Notice of Intent

Type of Action: Plug and Abandonment

Procedure Description: Matador requests the extension of the previously approved NOI P&A. Matador has had trouble securing a P&A rig, but Matador has secured a rig and plan to plug in or around May 1.

Conditions of Approval

Matador Production Company  
Federal 30 #1  
1980' FSL & 760' FEL Sec 30 - 195 - 33E  
Lea County, NM  
API: 30-025-27069  
**PROPOSED P&A WELLBORE SCHEMATIC**  
Spudded: 6/19/1981

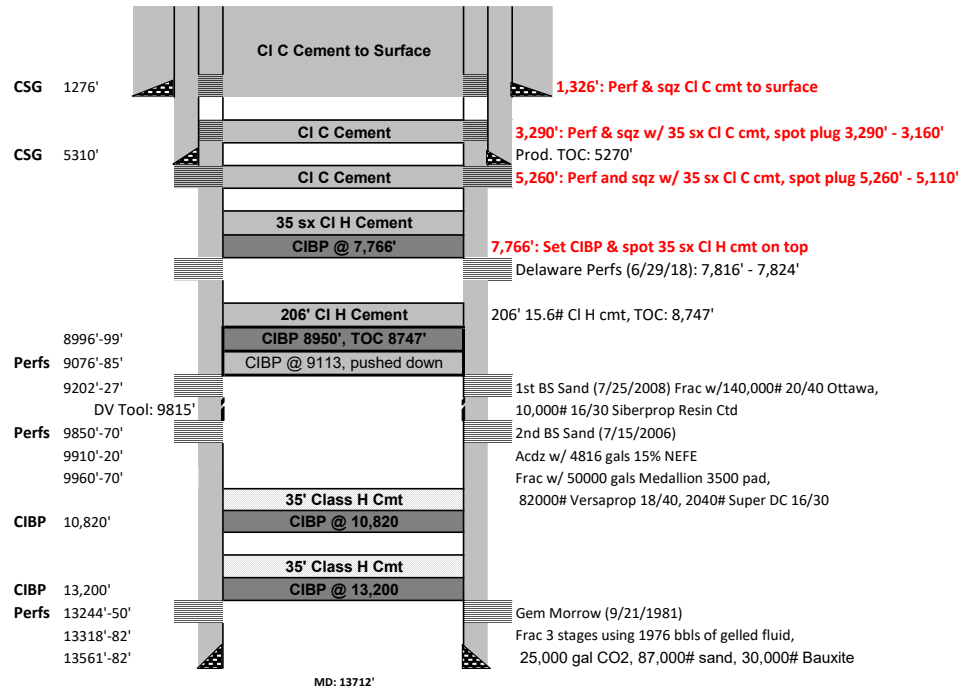
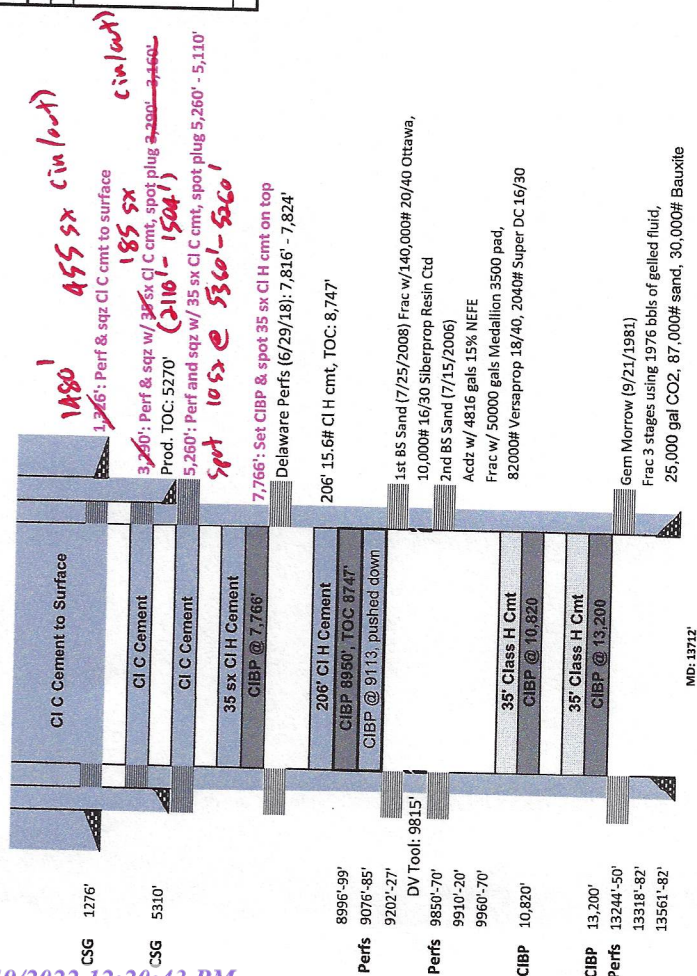
RIIIP, Capitan Reef, Prairie Chicken

- Notify NMOCD 24 hrs before MIRU.
- Safety mtg, MIRU, check pressures, pull rods and pump.
- ND wellhead, NU BOPs & TOOH w/ tbg.
- RU WL. WL set CIBP @ 7,766'. RD WL. TIH w/ tbg and spot 35 sx CI H cmt on top of CIBP. WOC & Tag. (7766' - 7482') Leak test CIBP
- Circ and displace hole w/ MLF. Come up & perf @ 5,260, sqz CI C cmt. Spot from 5,260 - 5,110'. WOC & Tag. 50 SX 5260 5260'
- Perf @ 3,290' & sqz CI C cmt. Spot from 3,290' - 3,160'. WOC & Tag. (2110' - 1504')
- Perf @ 1,326' & Sqz CI C cmt to surface. (1480' - surface) 455 SX (in/out) 185 SX 2 In/out)
- Cut off wellhead and ensure cmt to surface on all csg strings.
- Install above ground marker per BLM and NMOCD specifications.

7 (5360' - 5260') spot 10 sx class C
